DRAWING NUMBER	PROJECT	NUMBER	REV	SHEET
	KMRC	27012	11	1

SIGNALLING PLAN - MAIN LINE (PHASE-2)

KOLKATA EAST-WEST METRO RAIL PROJECT

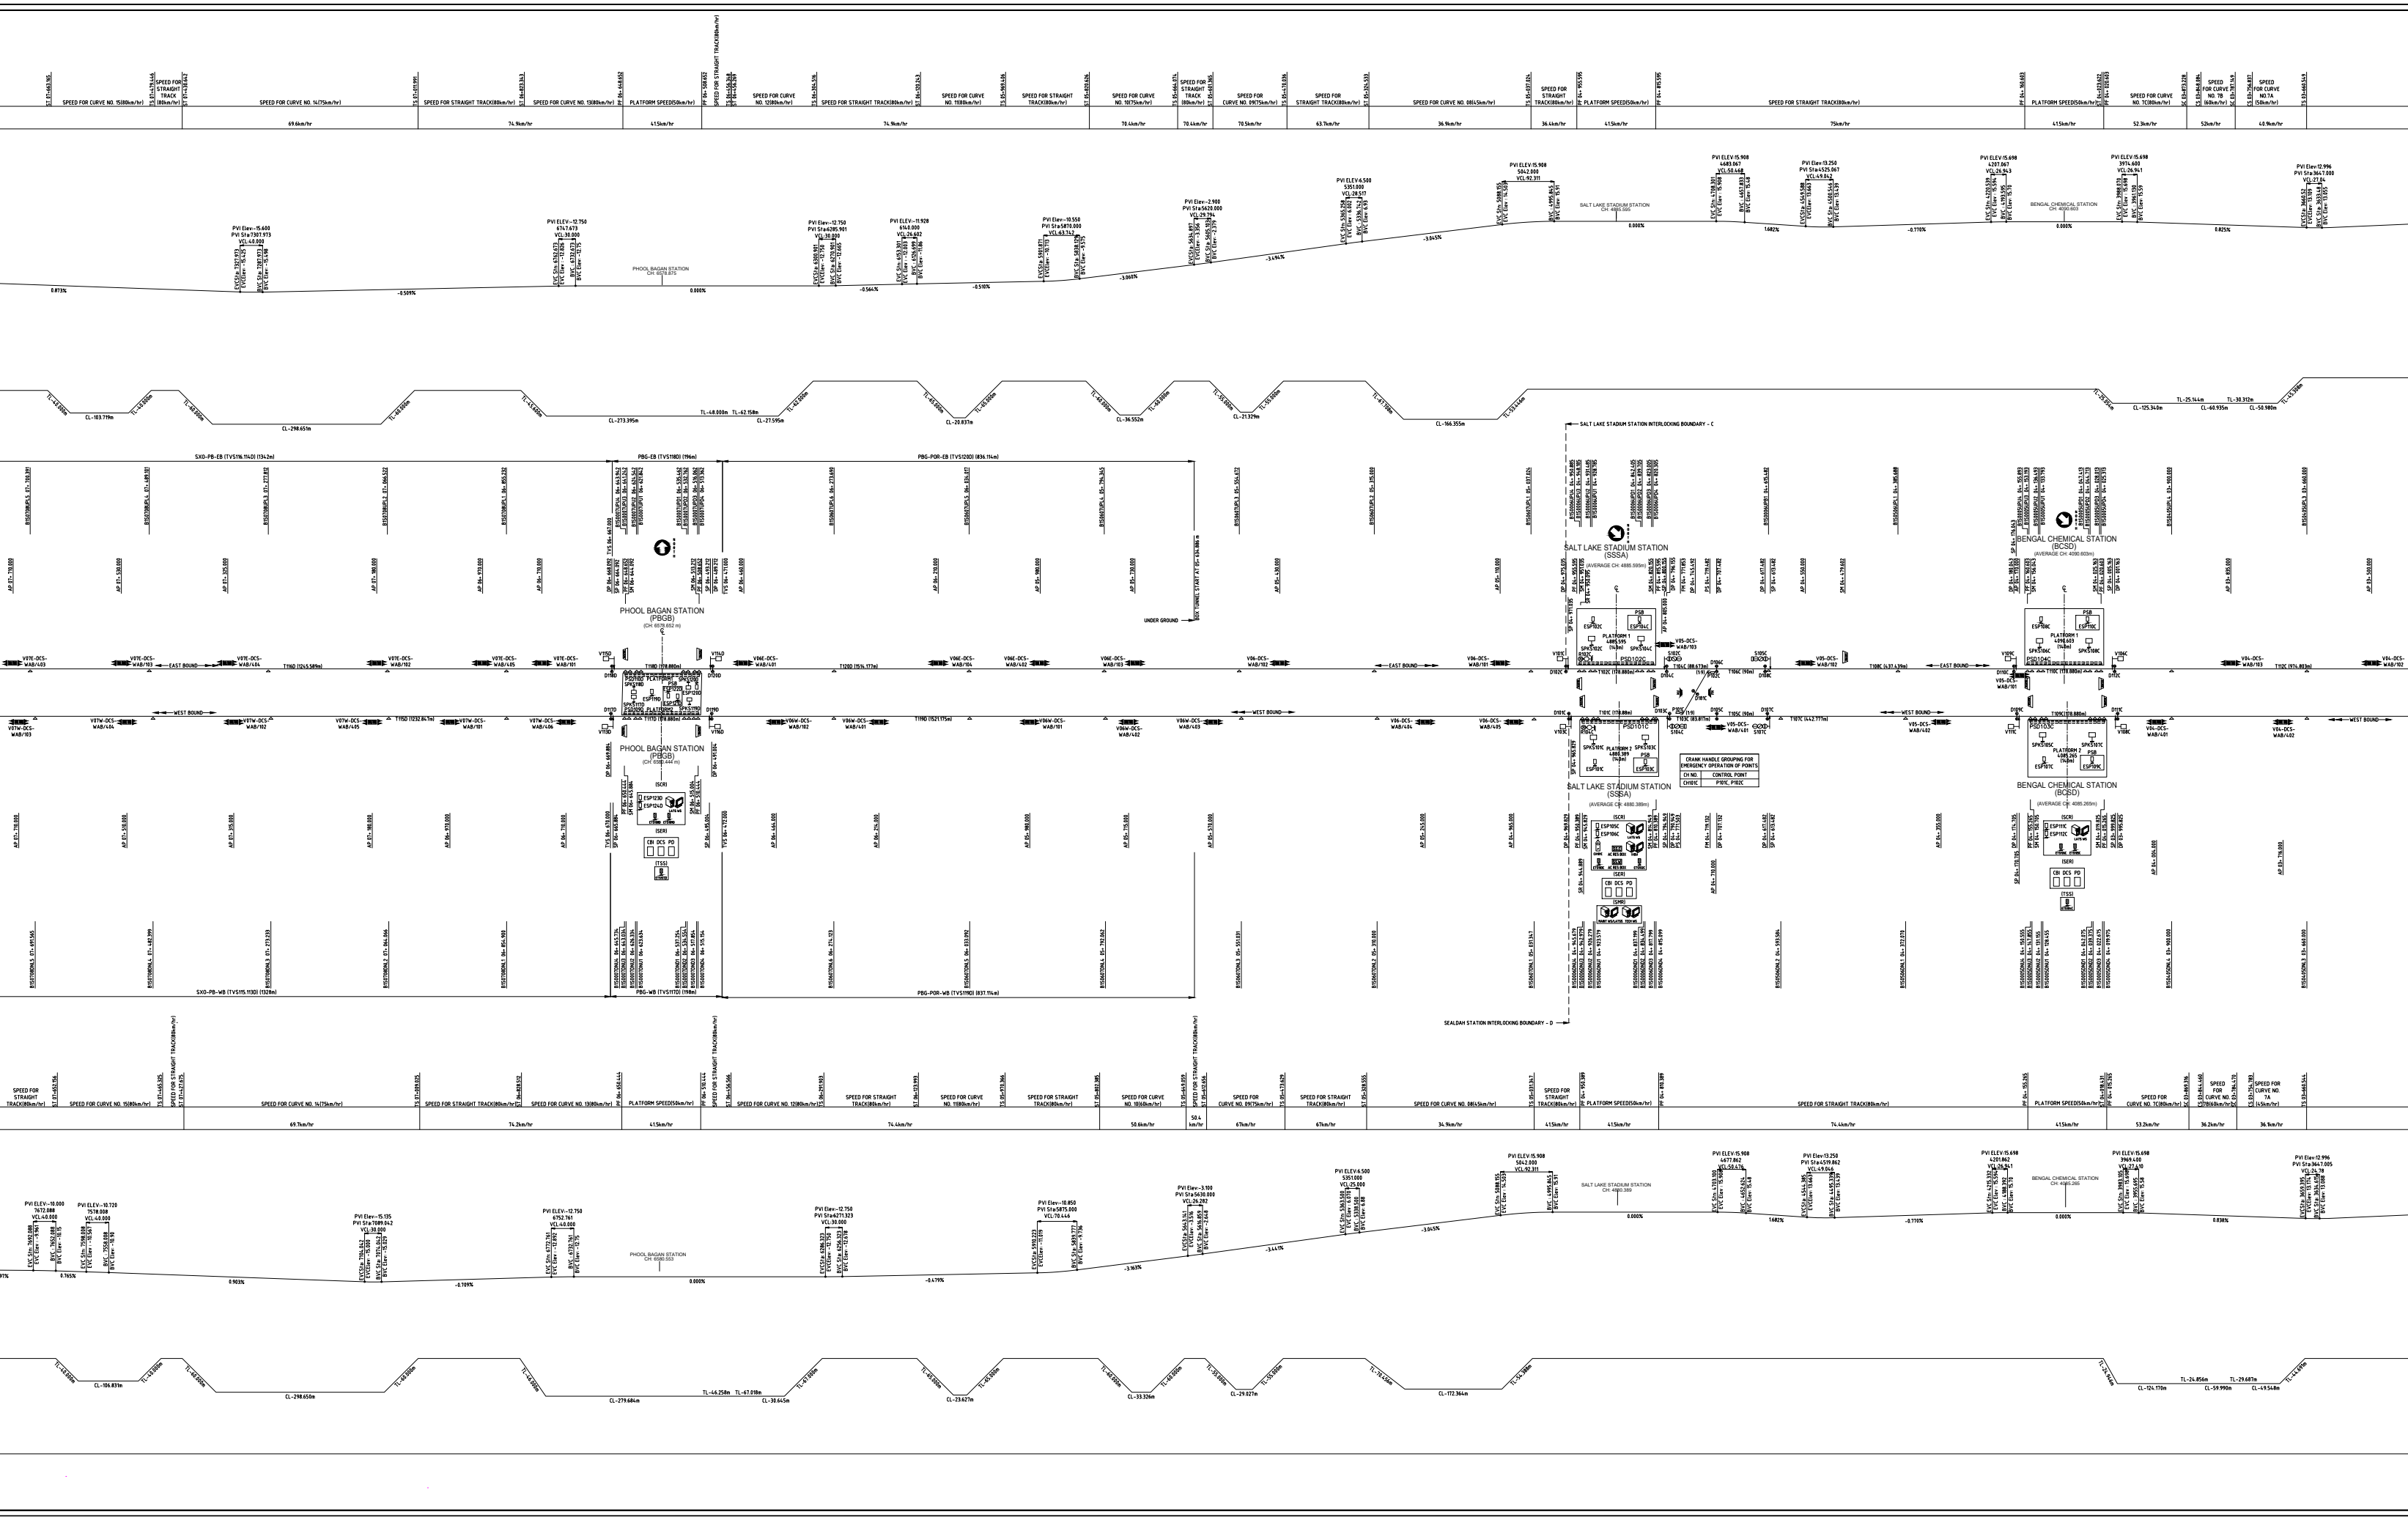
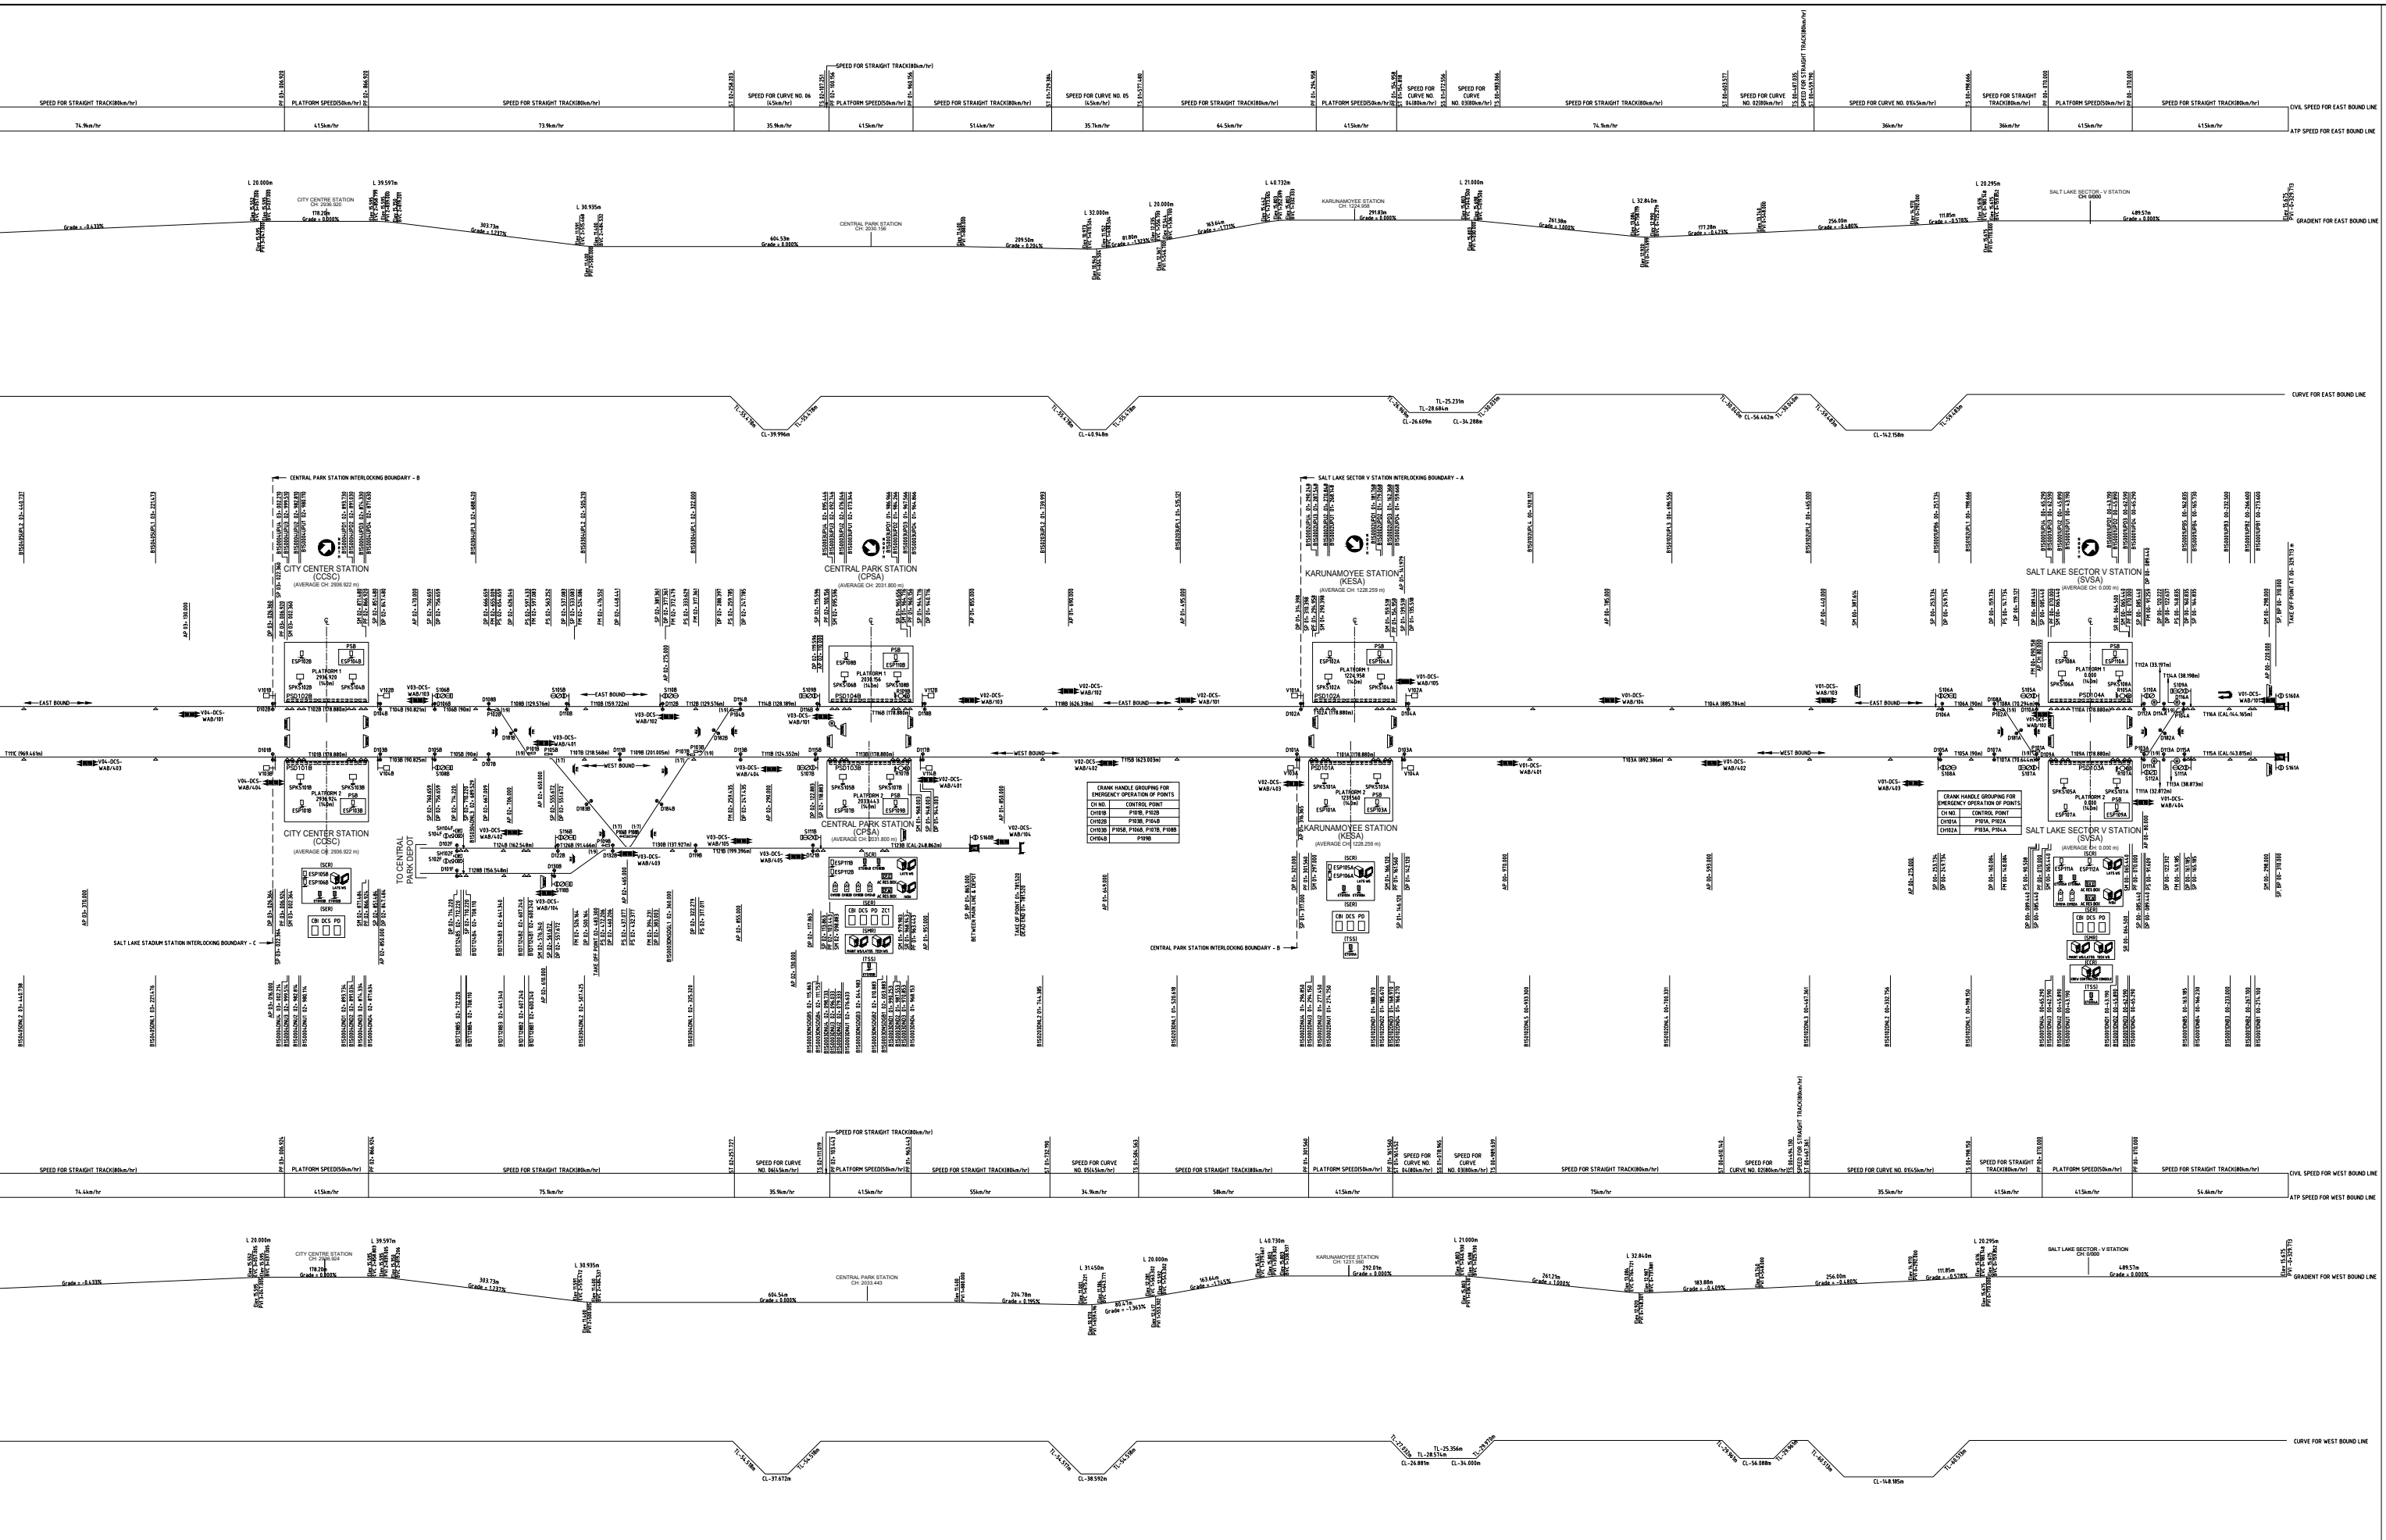
1. UPDATED AXLE COUNTER DP AND BALIESES ON WB LINE, AS PER THE REF. LETTER NO. 1147-24_122, DT.10.06.24
2. SUBODH MALLICK SQUARE VENTILATION SHAFT DELETED ON THE PLAN AS PER THE REF. LETTER NO. 1147-24_122, DT.10.06.24

3. EXISTING TVS SECTIONS UPDATED BETWEEN SEALDAH AND ESPLANADE OF WB AND EB AS PER THE REF. LETTER NO. 1147-24_122, DT.10.06.24
4. UPDATED IN THE AMENDMENT NOTE FOR REV. 10 SL.NO.8, AS PER THE REF. LETTER NO. 1147-24_122, DT.10.06.24

5. UPDATED (SHEET NOS. 01 TO 06) ADDED AFTER TRACK ALIGMMENT DRAWING AS PER THE 10028-ALN-DWG-WB-0002, REV.01, SHEET NO:-1 TO 6, DT.27.03.23.
6. UPDATED SYMBOL FOR TUNNEL MOUNTING MAIN SIGNALS AS PER THE REF. LETTER NO. 1147-24_122, DT.10.06.24

7. UPDATED SPASE BETWEEN THE TEXT PLATFORM-1A & SPKS 112D AS PER THE REF. LETTER NO. 1147-24_122, DT.10.06.24
8. AS PER REV. 10 SHOWN IN THIS PLAN ARE CORRECT AND AS PER THE APPROVED TRACK ALIGNMMENT DRAWING NO. 10028-ALN-DWG-WB-0002 (SHEET NOS. 01 TO 06) FOR WEST BOUND

9. UPDATED BOUNDARIES LINE BETWEEN PHASE 1 & PHASE 2 IN DOTTED LINE COVARED THE ACTUAL AREA OF SEALDAH STATION. PLATFROM 2A & 2B UP TO EXISTING BUFFER ON WB LINE COVARED THE RED PORTION OF THE PLAN SHOWN IN PHASE 2.

10. ATP SPEED MENTIONED IN SIP AS PER REV-10 IT IS SIMILAR TO PHASE-2A.
11. ACCORDING TO CURVE NO.23 AND DRAWING NUMBER 10028-ALN-DWG-0002 DATED 27.03.2023, THE SPEED IS UPDATED TO 72 km/h INSTEAD OF 60 km/h IN THE SEALDAH-ESPLANADE WB LINE IN THE SIP

12. UPDATED BALISE SYMBOL AT CHAINAGE 9.867, AND IT IS SHOWN AT THE BOTTOM OF THE LINE.
13. 'ST' & 'TS' CHAINAGES ALL MATCH AND ARE OKAY FOR EACH CURVE AS SHOWN IN SIGNALING PLAN WITH THE 'AS BUILT TRACK ALIGNMENT PLAN'.
